ONE 90 (PREVIOUSLY WATERS TECHNOLOGY PARK )  
PA 18-013 MODIFICATION SUBMITTAL :  
ISSUE DATE: 10-13-20

PA MODIFICATION - INTENT AND DESCRIPTION:  
To review and approve architectural building related design modifications made during plan check for code compliance and constructibility.

PA MODIFICATION COBALT- BLOCKS REVISIONS SUMMARY

PA MODIFICATION - INDIGO ROWS REVISIONS SUMMARY

FOURTH LEVEL PLAN

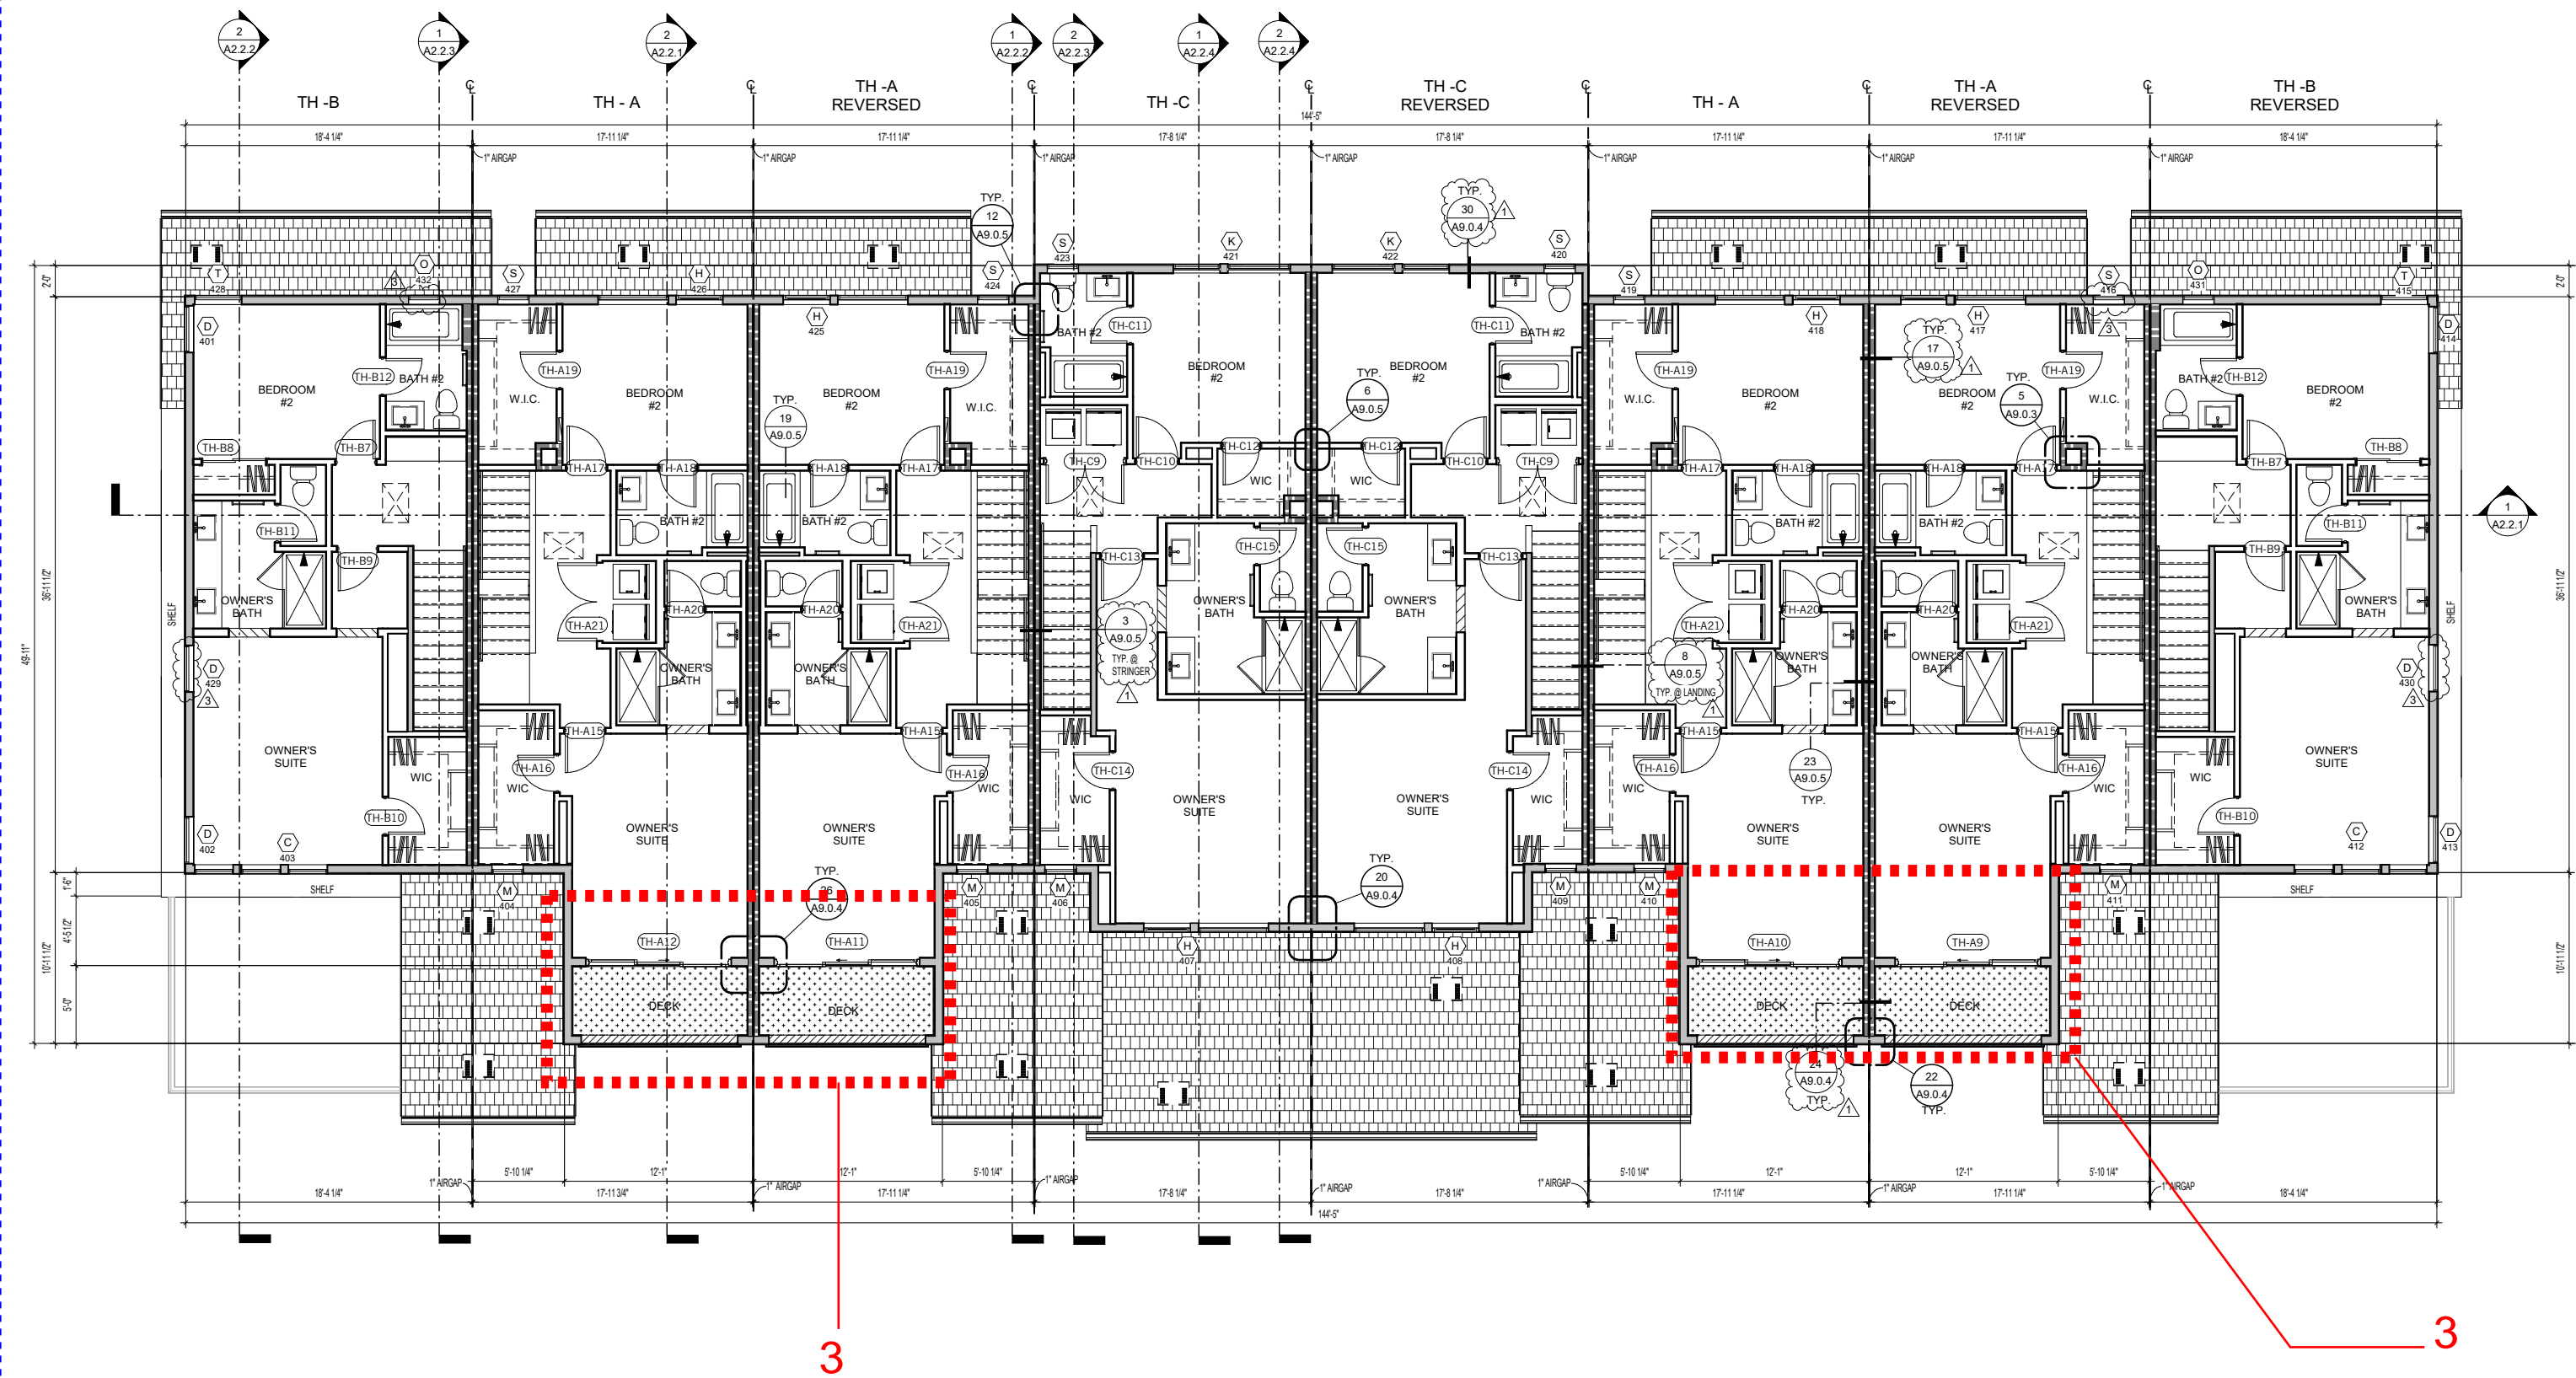
1. Egress balcony at third floor connecting two exit stairs.
2. Enclosed balcony with Flat roof ILO trellis to prevent water intrusion in unit below.
3. Added private balcony on fourth floor for TH units since these units lost their private balcony on third floor to Egress balcony

12 UNIT ELEVATIONS CS-1

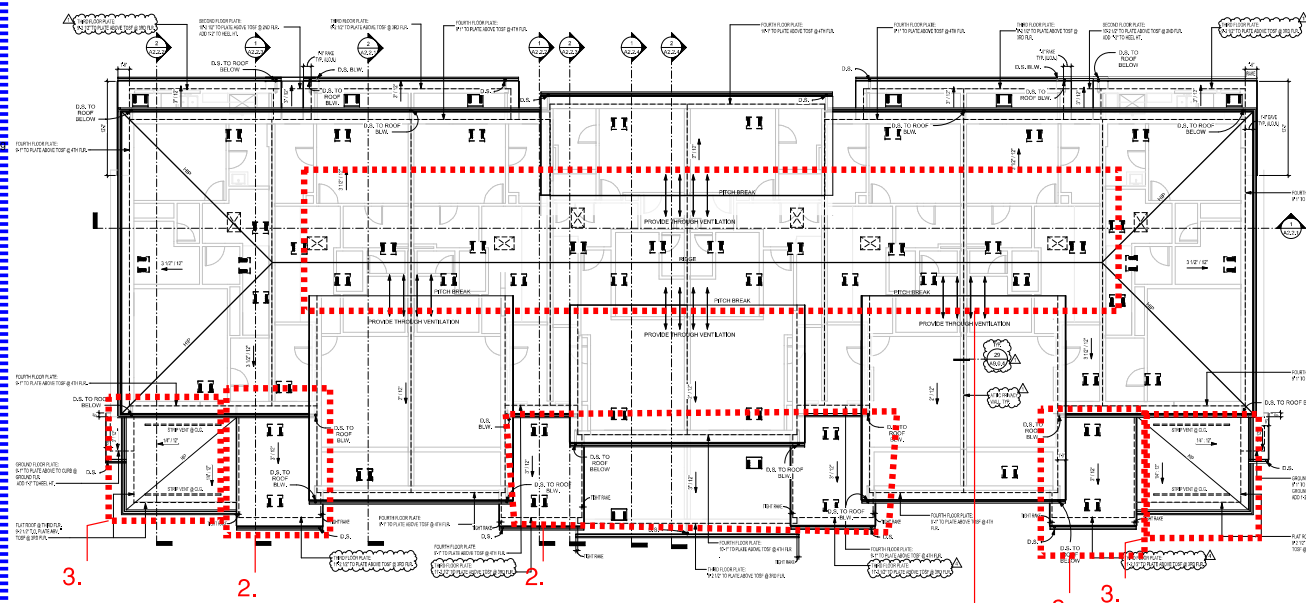
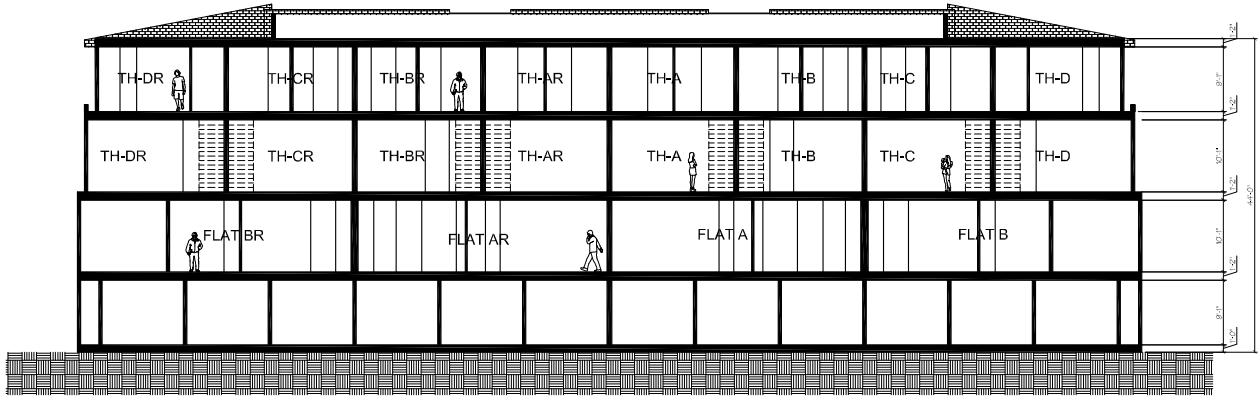
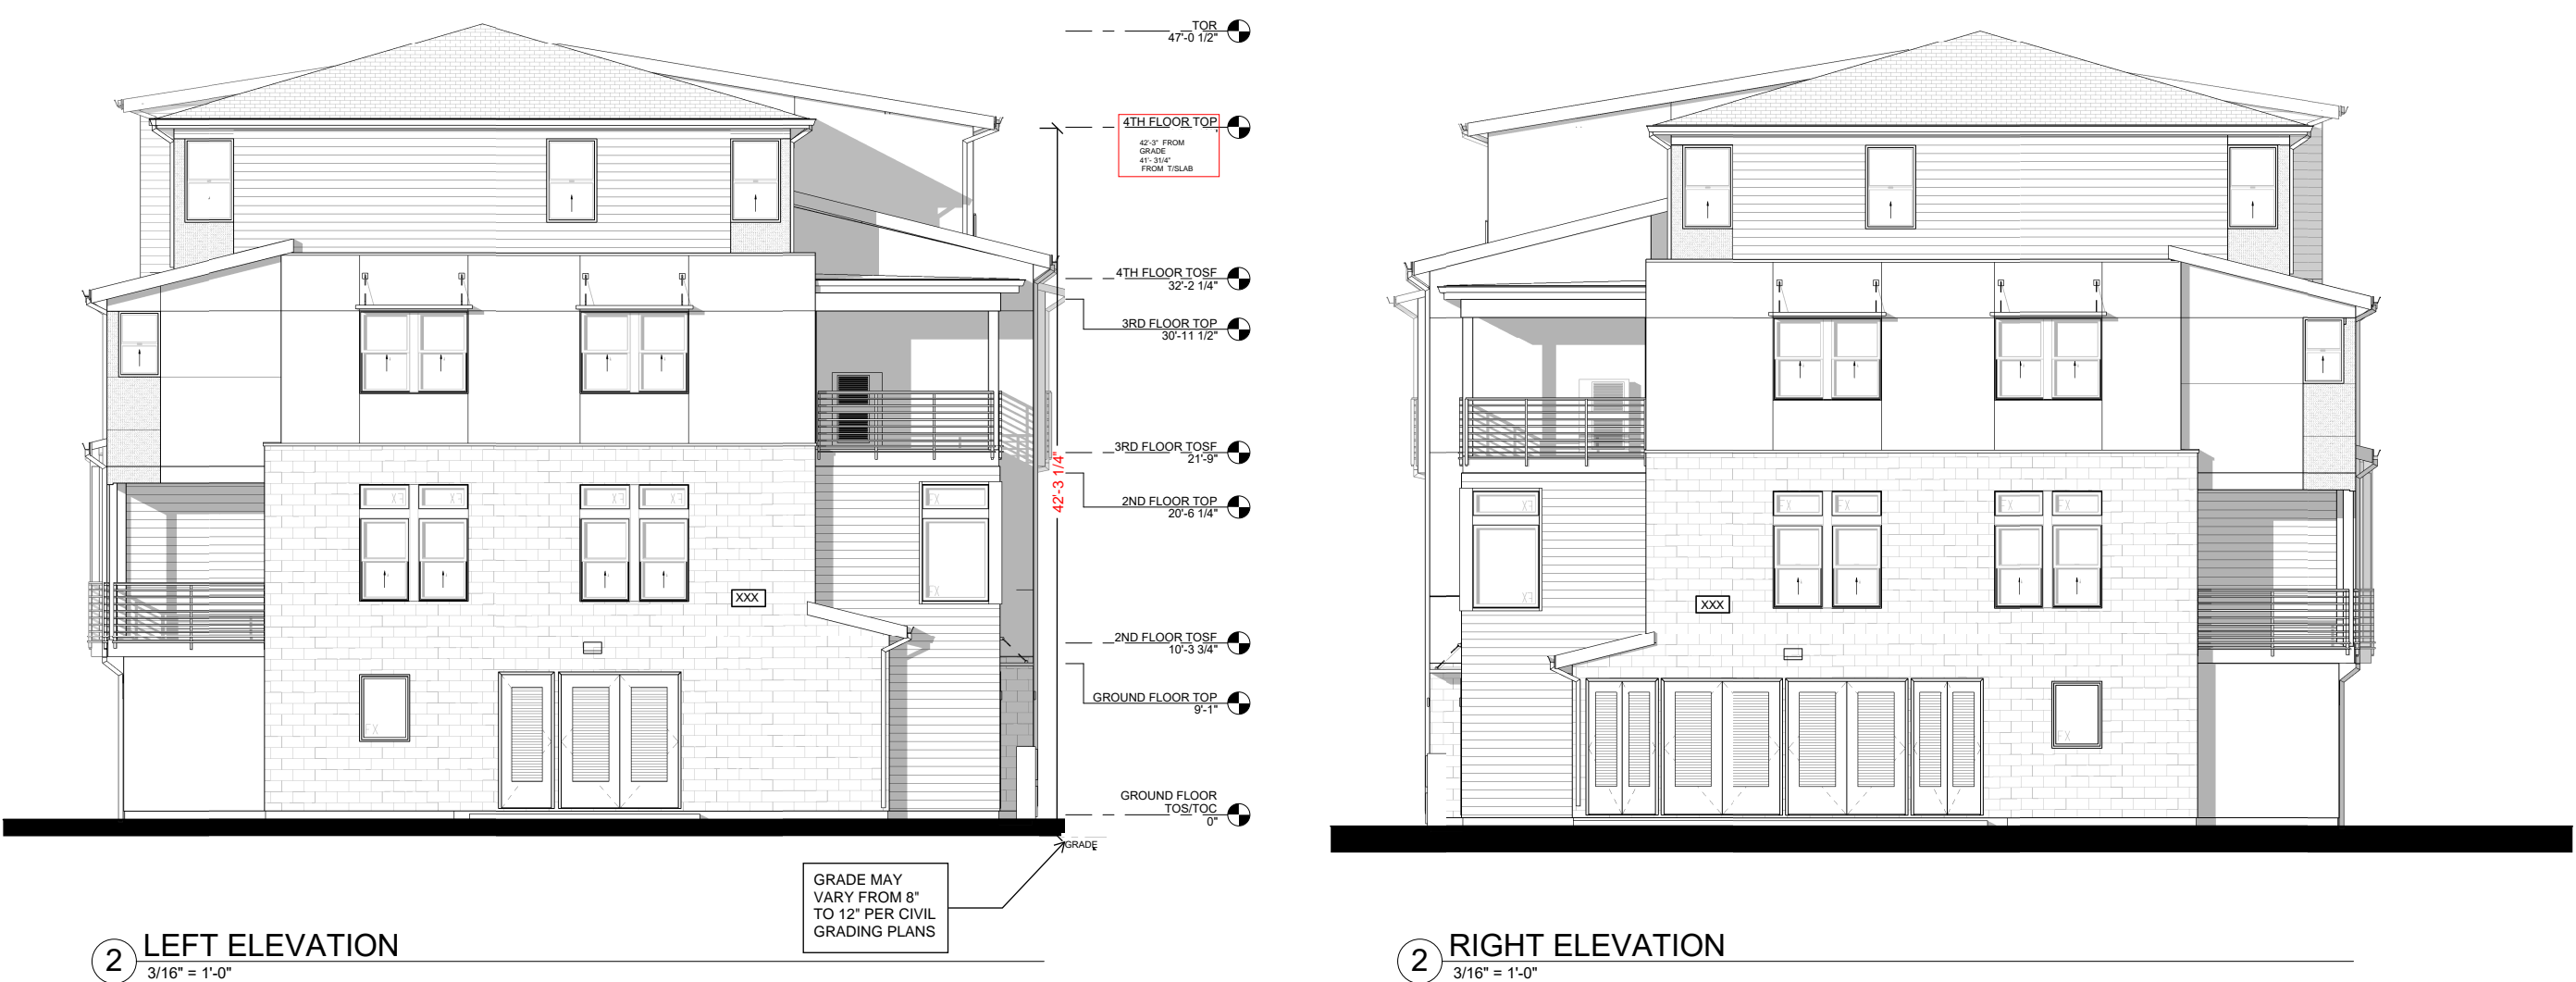
- List Of Revisions:
1. Revised roof from Mansard to Hip roof to aid in providing required solar area per T-24.
  2. Lower roofs have been revised from metal seam to cool roof Asphalt Shingles to match the main building roof. These revisions were required to meet SMC reach code plan check comments and T-24.
  3. Added flat TPO roof in lieu of trellis over balcony to prevent water intrusion in unit below.
  4. First floor plate height is revised to 9'-1", second floor plate height is revised to 10'-2 1/2", third floor plate height is revised to 9'-2 1/2" to accommodate floor sheathing and acoustic layer. Decrease in overall plate height since third floor changed from 10'-1" to 9'-2 1/2" height.

1. Revised roof from Mansard to Hip roof to aid in providing required solar area per T-24.
2. Lower roofs at front and rear have been revised from metal seam to cool roof Asphalt Shingles to match the main building roof. These revisions were required to meet SMC reach code plan check comments and T-24.

3. Added flat TPO roof in lieu if trellis over balcony to prevent water intrusion in unit below.
4. Common stairs revised to have wall openings without any windows or doors to meet open stair requirement per building code.

5. Planter walls were removed to comply with updated site development plans and bio-swale locations. AC units are located in this area and will be screened with planting per landscape plans.

6. Canopy from second and third floor windows have been removed to avoid conflicts with ladder pad locations.
7. Added private balcony at fourth floor above egress balcony per direction from planning

8. Electrical closets were extended to meet PGE clearances.
9. Metal trellis has been changed to wood composite trellis framing members.
10. All Windows color has been revised to Tan color. Bottom transom windows from all floors have been removed due to height limitations and floor assembly. Upper transom windows have been removed from third floor due to height limitations. All windows have been revised to show single hung operation, fixed or slider to meet adequate egress requirements.
